Product hierarchy no.				Part no.	SBU	Product Type	Customer part no.
SBU	PG	PUG	Type				
01	002	003	0000000679	0031.1801 0031.1803 0031.1804	Circuit Protection	FEU (Grip)

Product Change Notification					PCN FEU (Grip) Change of material		
owner	creation date	release date	released by	change order	rev	page	
zbindeja	23.10.2023	31.10.2023	schulejo	2026686	A	1 of 2	D10-079-351

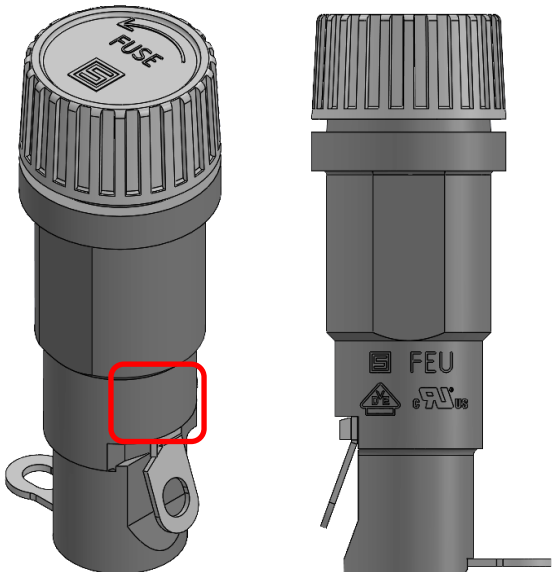
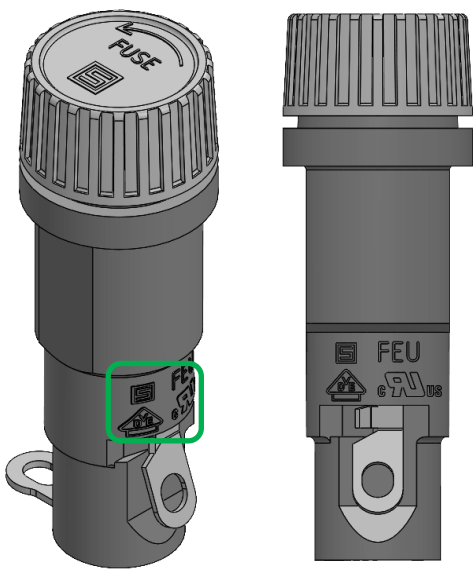
Current material	New material
Thermoset	Thermoplastic
Current product appearance	New product appearance
	 <ul style="list-style-type: none"> <li>Product marking shifted by 90°</li> </ul>

- Replace plastic material thermoset with thermoplastic for more reliable moulding process

| <input checked="" type="checkbox"/> Form | No action required. Consider new product appearance at incoming inspection |
